SERVICE INFORMATION NO. SI 40-151

Andair Fuel valve system with extension

SERVICE ALERT

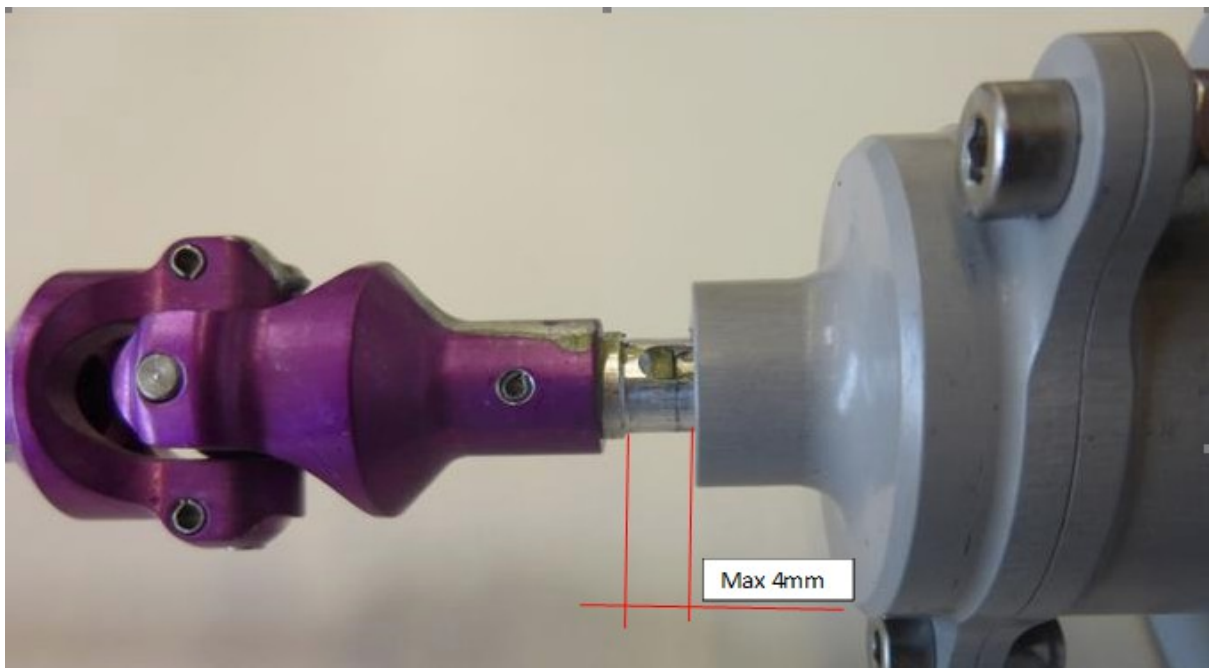
Andair has issued a Service Alert describing that certain fuel valve systems with extension may have a possible lack of engagement between the universal joint assembly and the top of the valve assembly.

This Service alert applies to all Diamond Aircraft fitted with this extension system. It has been brought to our attention that there could be a possible lack of engagement between the universal joint assembly and the top of the valve assembly. It is requested that a check be carried out to establish a minimum of engagement of 5mm with the dowel in the valve assembly. The picture below gives a maximum dimension of 4mm. Less than this can be considered satisfactory, this gives over 5mm engagement. Greater than this, the assembly should be investigated further and a new longer dowel be fitted. The longer dowels can be supplied.
